TOWN OF CHAPIN
Architectural Review Board
Regular Meeting
Council Chambers, Chapin Town Hall
August 6, 2025
6:00 PM

To: Architectural Review Board
From: R. Radtke, Planning & Zoning Manager
Date: July 16, 2025
Re: Outparcel 3– Medical Office

To: Architectural Review Board
From: R. Radtke, Planning & Zoning Manager
Date: July 23, 2025
Re: Carolina Wings – Commercial Sub-division

To: Architectural Review Board
From: R. Radtke, Planning & Zoning Manager
Date: July 17, 2025
Re: Express Oil – Commercial Sub-division

DRAWING NUMBER:
C2.0

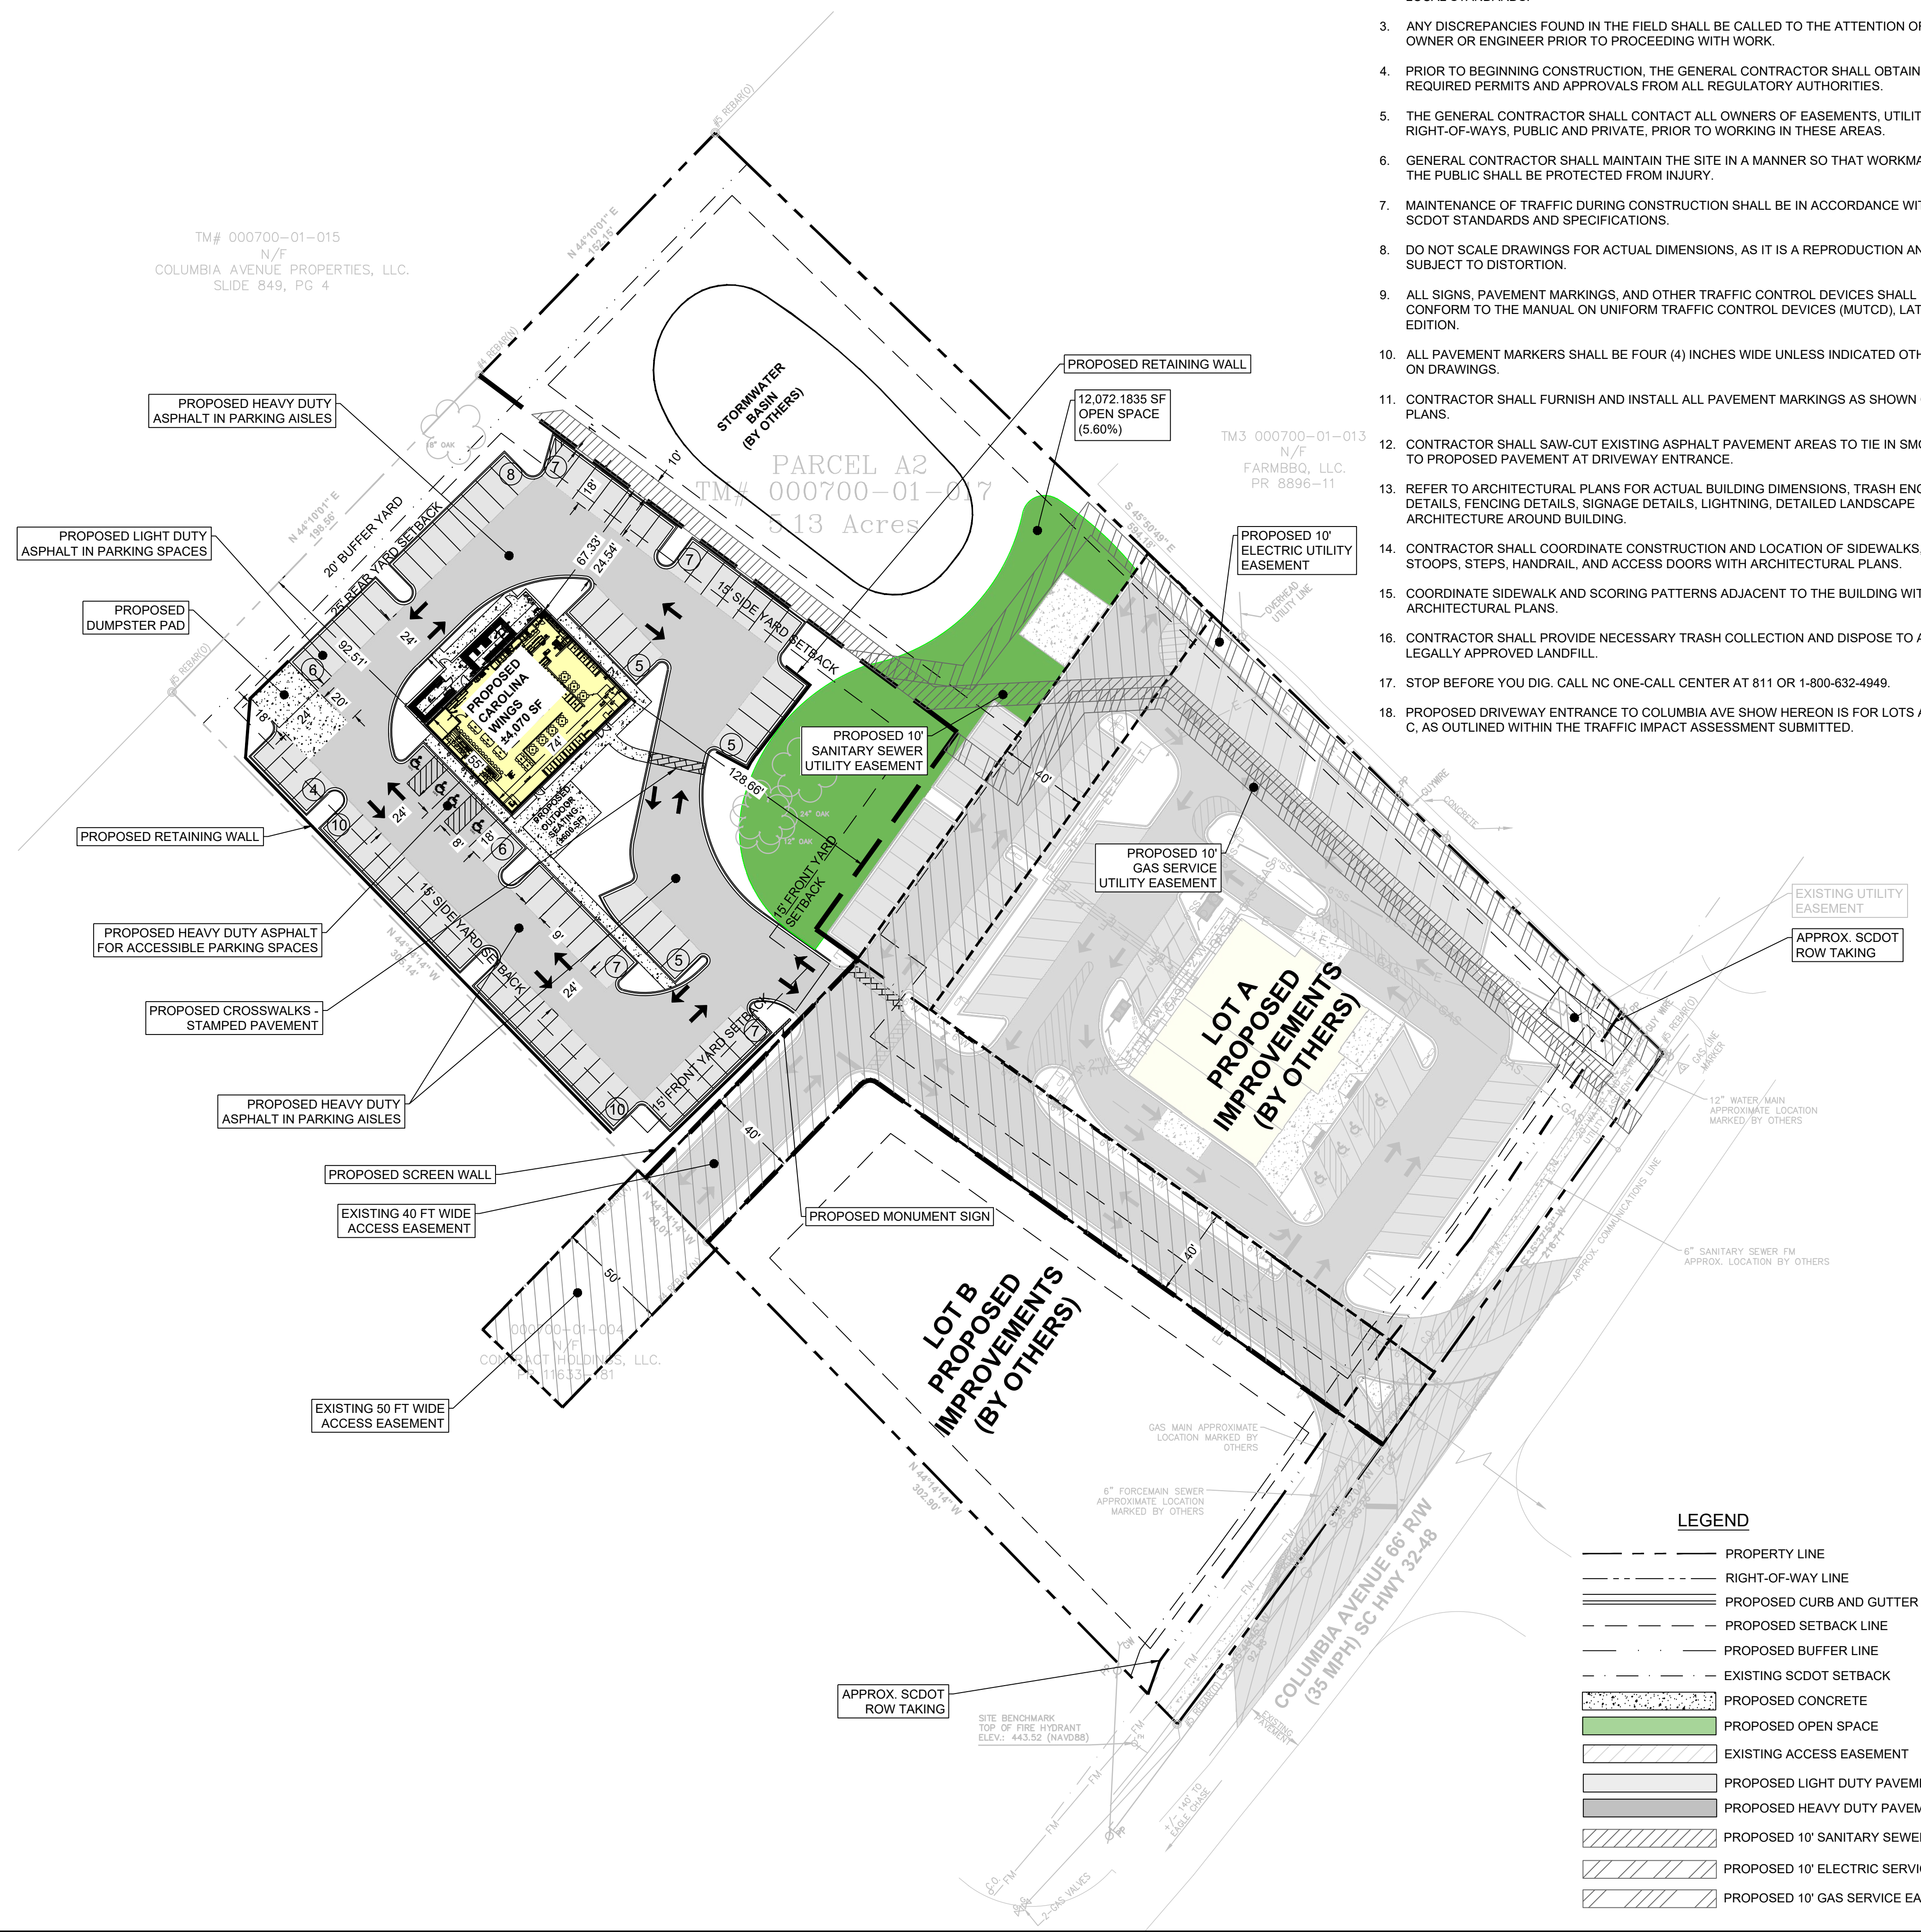
- Details and locations needed for open space to be shown on plan. **(5.4.1).**
- Plan does not show any pedestrian interconnectivity as required – **8.6.3**

1. Exterior Lighting plan.
2. Traffic Impact Study
3. Include traffic design for crosswalks and interconnectivity.

C2.00

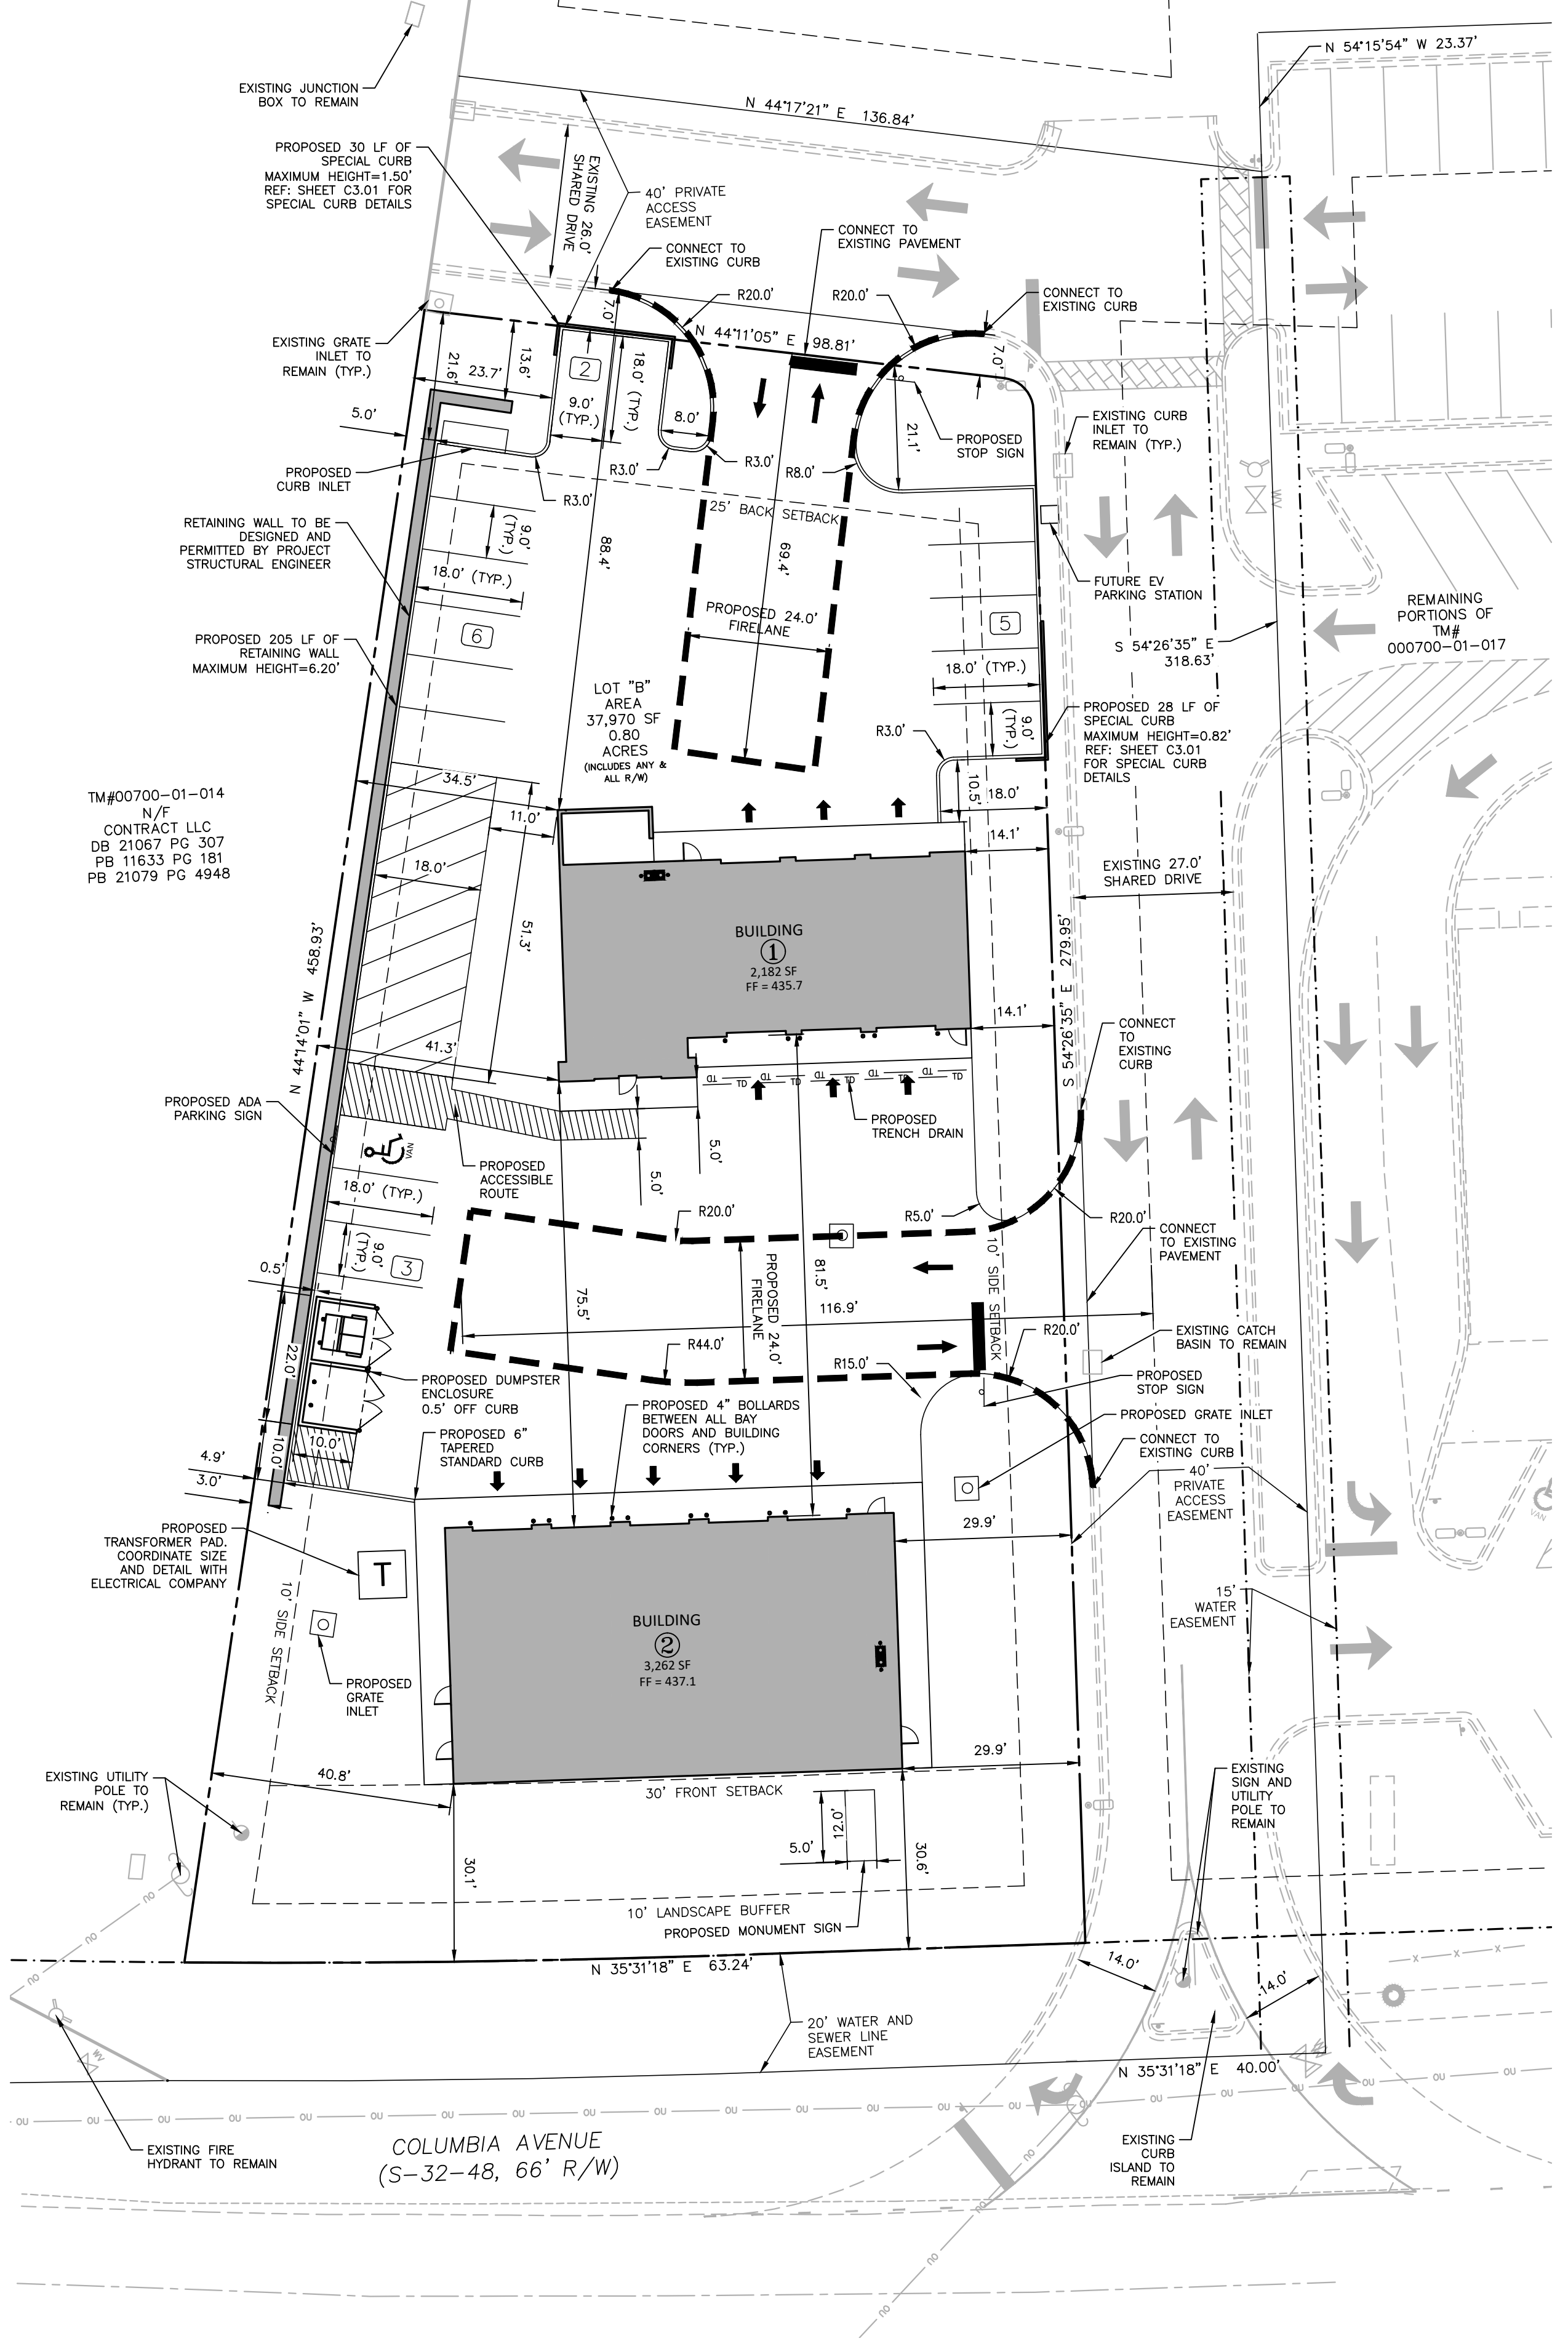
Total size of the building is 2957 Sq. Ft. / 1 space per 150 Sf = 24 Spaces. Applicant has planned for 15 spaces. Appears to be short of minimum required.
